Subdivision Staff Report

Subdivision Name	Plano Road Subdivision	File Number	SUB07-00065
Approval	Preliminary Plat	Lead Agency	Boise City
Annexation Date	N / A	Comp. Plan	Complies
Public Hearing Date	July 14, 2008	Heard by	Planning and Zoning Commission
Analyst	Todd Tucker <i>TT</i>	Reviewed By	David Abo, AICP <i>DA</i>

This is a proposed residential subdivision with 155 buildable lots and eight common lots located on 323 acres. The density of the proposed subdivision is 2.08 lots per acre. The subject property is currently located in Ada County. There is an associated Annexation and Rezone Application (CAR07-00042) with this proposed subdivision. In addition, there is an associated Conditional Use Permit Application (CUP07-00084) and a Hillside Development Permit Application (CFH07-00022) that will also be heard at the June 9, 2008 Planning and Zoning Commission meeting.

C-1.1

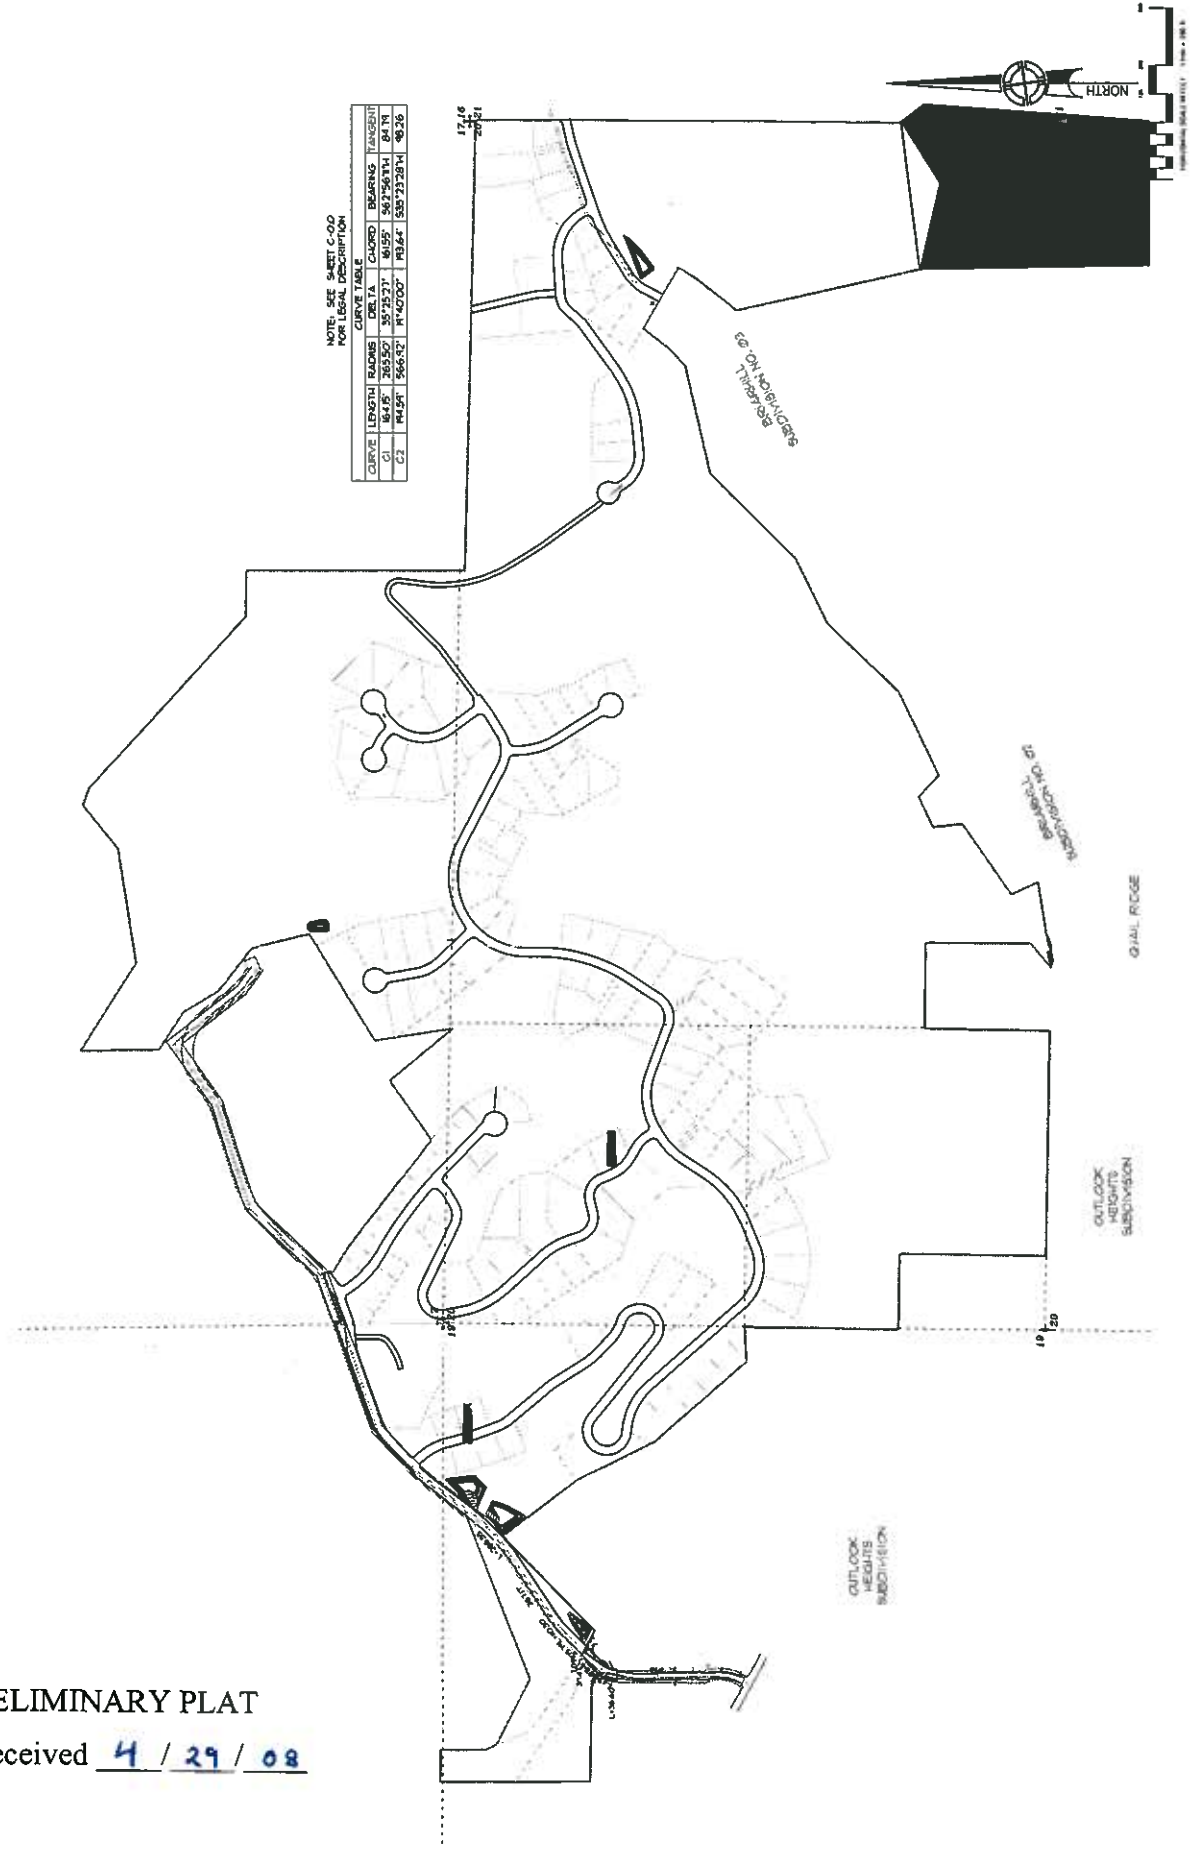
- The submitted Preliminary Plat identifies eight areas as open space. However, those eight open space areas are not identified as lots (common lots) on the plat. As such, the Preliminary Plat must be revised to show all common open space areas with lot numbers.

- The submitted Preliminary Plat shows a portion of W. Daylight Rim Drive as an emergency vehicle access. Due to the size of the development and the limited access via N. Plano Lane / N. Plano Way staff recommends that W. Daylight Rim Drive be constructed as a continuous public roadway between the proposed N. Plano Way and the proposed extension of N. Collister Drive.

9. Prior to approval by City Council the Preliminary Plat shall be revised to show all common open space areas with lot numbers.
10. W. Daylight Rim Drive shall be constructed as a continuous public roadway between the proposed N. Plano Way and the proposed extension of N. Collister Drive.
